SUBJECT: DRAFT SAFETY EVALUATION FOR TOPICAL REPORT (TR) BAW-2308,
REVISION 1, "INITIAL RT_{NDT} OF LINDE 80 WELD MATERIALS"
(TAC NO. MB6336)

SAFETY EVALUATION BY THE OFFICE OF NUCLEAR REACTOR REGULATION

FOR TOPICAL REPORT (TR) BAW-2308, REVISION 1,

"INITIAL RT_{NDT} OF LINDE 80 WELD MATERIALS"

Figure 1 - Correspondence of ΔT_0 to $\Delta T_{30 \text{ ft-lbs}}$ (i.e., ΔT_{41J}) for RPV Welds, Plates, and Forgings

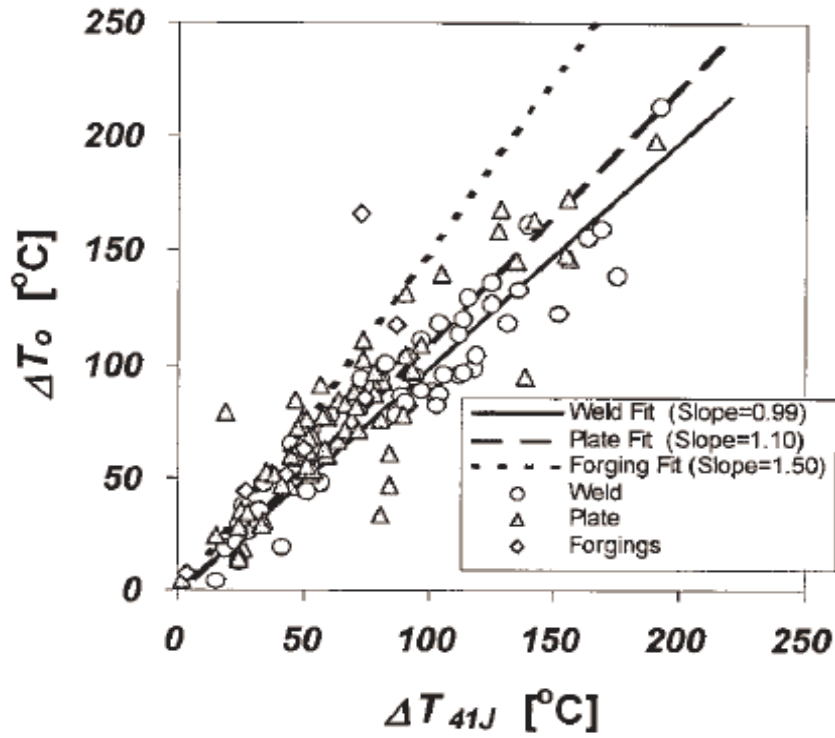
11 and the standard deviation of the residuals between the ΔT_0 data and the ΔT_0 vs. ΔT_{30}
12 regression line was 25.6 EF (see Figure 1).

1 BAW-2308, Revision 1. Based upon the information shown in Figures 1 and 2, the NRC staff
2 concluded that there is sufficient evidence to conclude that for welds in general, and Linde 80
3 welds in particular, the use of models based on ΔT_{30} in lieu of obtaining test data on the shift in
4 the Master Curve T_0 parameter is acceptable, provided that the margins used in the analysis
5 adequately covered the scatter in the ΔT_{30} vs. ΔT_0 correlation.

3 Figure 2 - Correspondence of ΔT_0 to $\Delta T_{30 \text{ ft-lbs}}$ For Linde 80 Welds

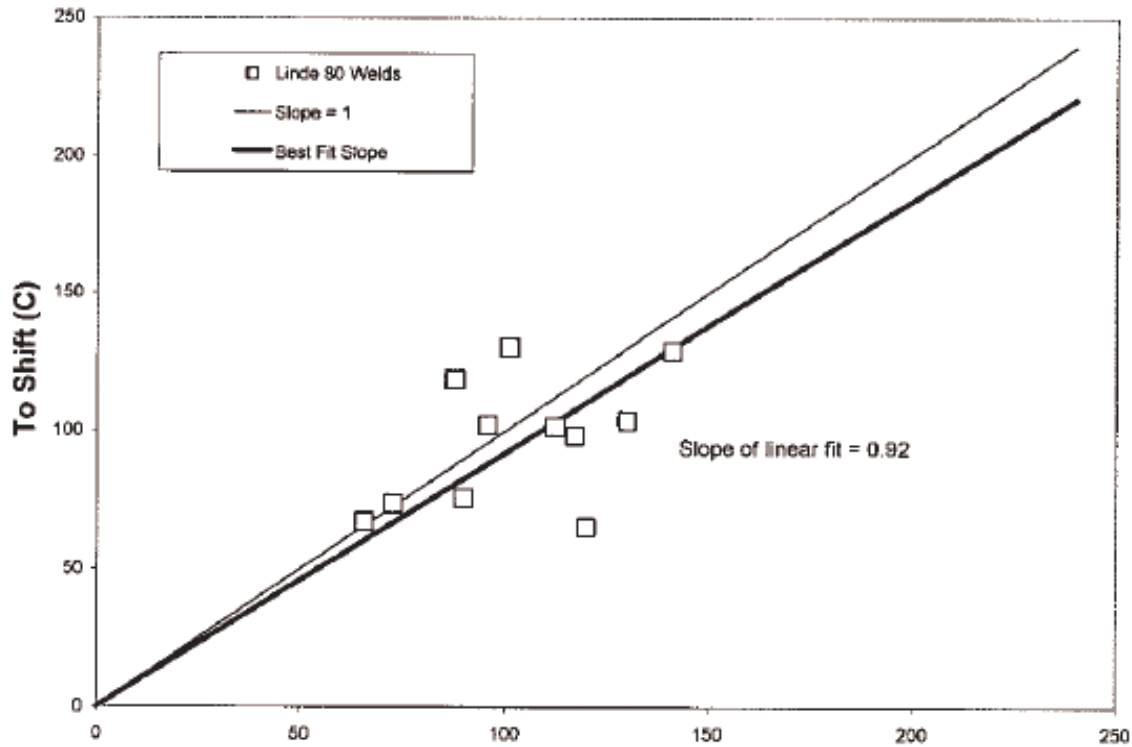
13 The B&WOG performed a similar analysis for 12 Linde 80 weld data pairs. The correlation for
14 the Linde 80 welds (see Figure 2) was:

6 The NRC staff evaluated the information presented in Figures 2 and 3 of this SE to determine if
7 the proposed use of a $\sigma_{\Delta} = 28$ EF was acceptable in conjunction with IRT_{T_0} and σ_I values based
8 on Master Curve testing and shift values based on the RG 1.99, Revision 2 model for welds.
9 When used in the margin term definition given in RG 1.99, Revision 2 and in Section 5 of TR
10 BAW-2308, Revision 1:

12 it is reasonable to consider whether a margin of $2\sigma_{\Delta} = 56$ EF is adequate to bound uncertainty in
13 the assessment of the shift in T_0 due to irradiation. The NRC staff observed that if a parallel line
14 is drawn offset by 56 EF (31 EC) above the one-to-one correlation line given in Figure 2 of this
15 SE (i.e., a parallel line which would represent the 56 EF of margin), that the data points would be
16 conservatively bounded. Further, the NRC staff observed that the data in Figure 3 of this SE
17 demonstrate that the use of a mean trend curve from RG 1.99, Revision 2 based on average
18 Linde 80 weld chemistry plus a $2\sigma_{\Delta}$ margin results in the measured ΔT_0 values being bounded,
19 provided that, at a minimum, a chemistry factor of 167 EF is applied. Based on these
20 observations, the NRC staff concluded that the use of $\sigma_{\Delta} = 28$ EF in conjunction with IRT_{T_0} and

2 Figure 3 - Correlation of ΔT_0 data with Regulatory Guide 1.99, Revision 2 Prediction +
3 Margin

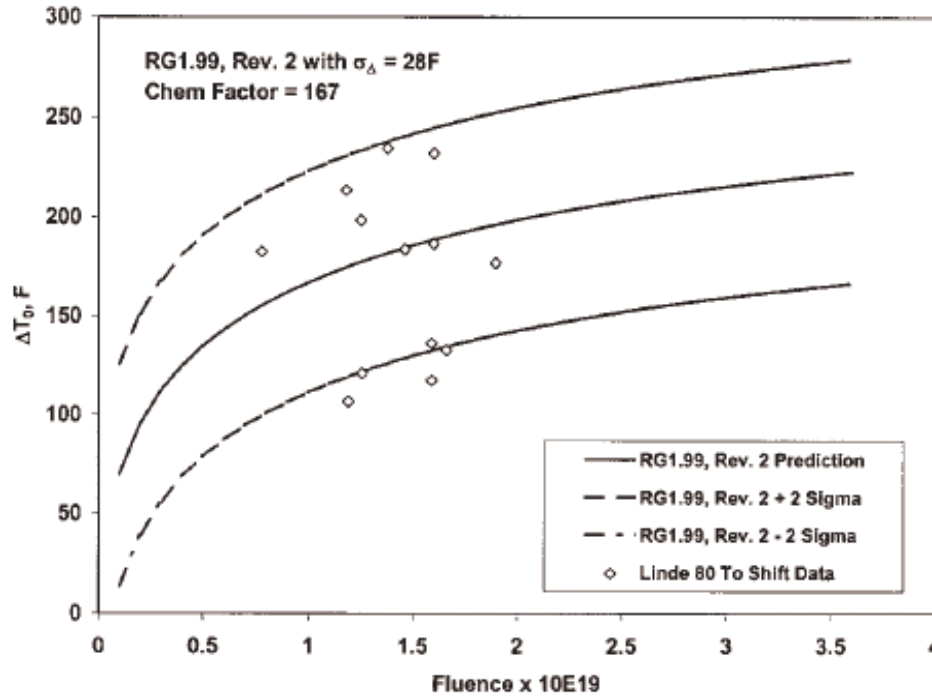
12 properties due to irradiation, even though the RG 1.99, Revision 2 methodology is based
13 upon Charpy V-notch 30 ft-lb energy level shift data. However, based on the information
14 in TR BAW-2308, Revision 1 (see Figure 3 of this SE), a minimum chemistry factor of
15 167 EF must be applied when using initial properties given in Table 3 of this SE. A
16 higher chemistry factor may be required if weld wire heat-specific chemical composition
17 or Charpy V-notch surveillance data indicate, via the methodology of RG 1.99, Revision
18 2, that a higher chemistry factor should apply.
